NUMBER: S.I. M20-67
DATE: 10-12-83

SUBJECT: IMPROVEMENT OF ENGINE COMPARTMENT TEMPERATURE DISTRIBUTION, M20K.

MODELS/S/N AFFECTED: MOONEY M20K, S/N 25-0001 thru 25-0738.

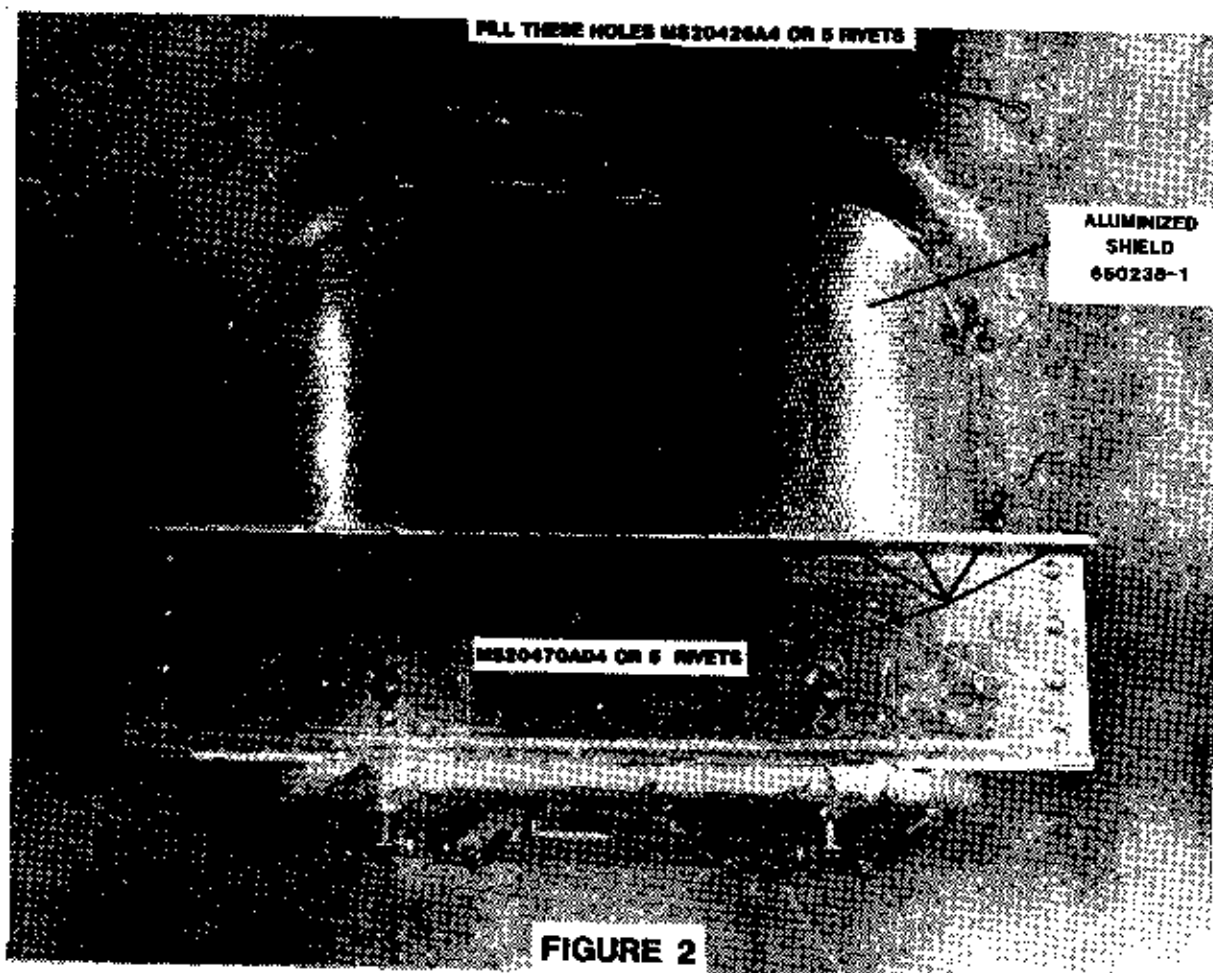
1. Remove top and bottom cowling per M20K Service and Maintenance Manual.
2. Remove the old J-7444-30 cowl snubbers (mounts) from the crossover tube of engine mount (see Figure 1). Save the attaching bolts, nuts, washers and shims for attachment of new J-7444-34 cowl snubbers (mounts) and heat shield P/N 600337-1.

3. Inspect the paint on engine mount tube and gusset plate located directly aft of engine exhaust crossover stack. The gusset on left, front side of engine (on the right when facing engine from front) has been most affected by exhaust temperatures. (See Figure 1).

5. Install new J-7444-34 cowl snubbers and heat shield P/N 600337-1 with existing hardware. The shield should be mounted with the curved portion forward and down per Figure 1.

6. The shims, P/N 650229-1 (Ref. Fig. 1), that were installed on original snubber installation may not be required on the modified installation due to thickness of the heat shield now installed. When snubbers and shield have been installed, place lower and upper cowling into position and observe through the cowl flap area with an inspection mirror to determine if shims are required to obtain approximately 1/8 (.125) inch compression of snubbers. Remove cowling and install shims as necessary to obtain proper compression.

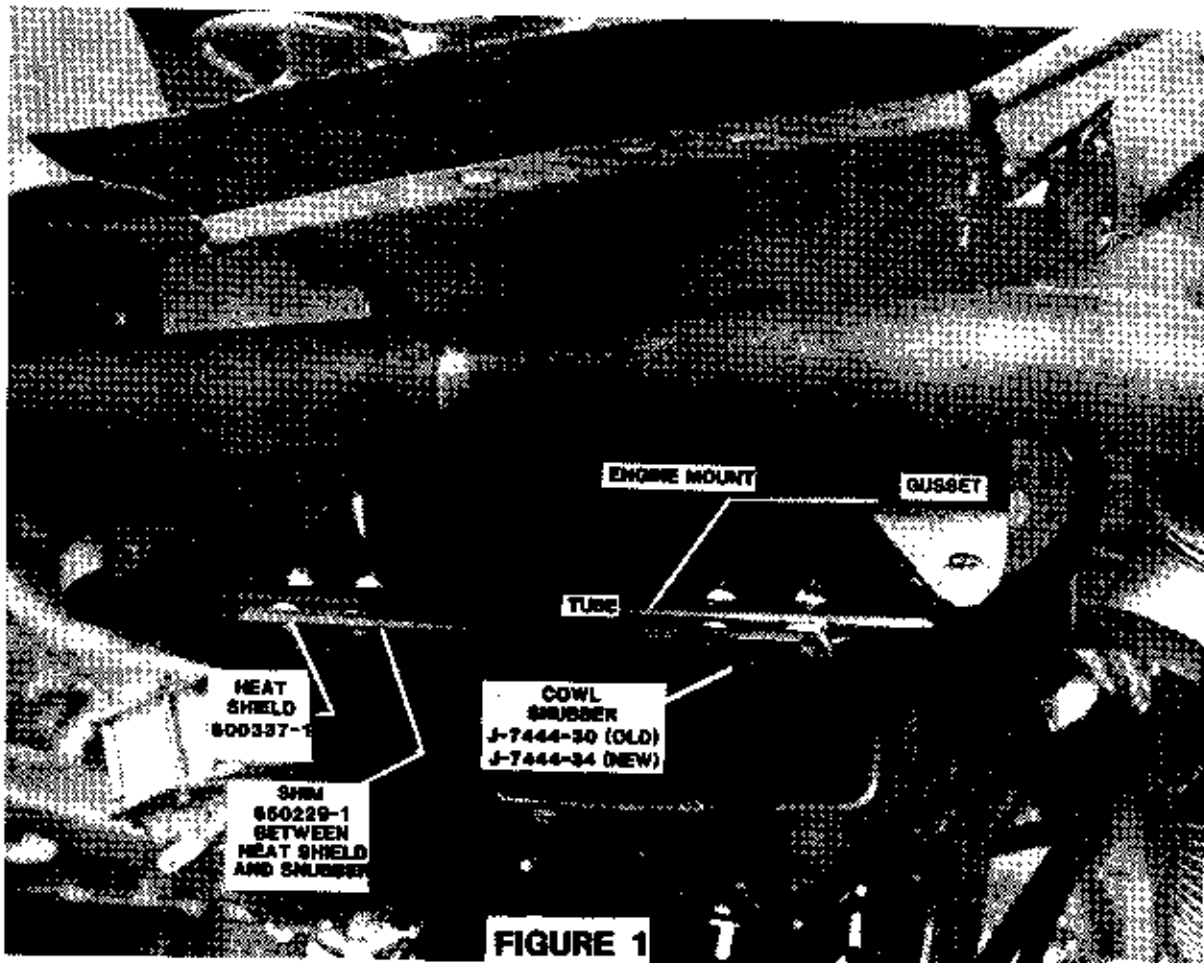
8. Clean top and side surface of landing light cavity molded into the lower cowling just ahead of metal light box. Glue the aluminized material (650238-1), aluminized side up, to this portion of the cowling using P/N 8001 (3-M) glue. Follow instructions on 3-M glue label for application and cure time. (See Fig. 2).

10. Install MS20470AD4 or ADS rivets, as needed, to secure the doubler to the flange of the metal light box from where the aft flange of heat shield was originally attached. (See Figure 2).
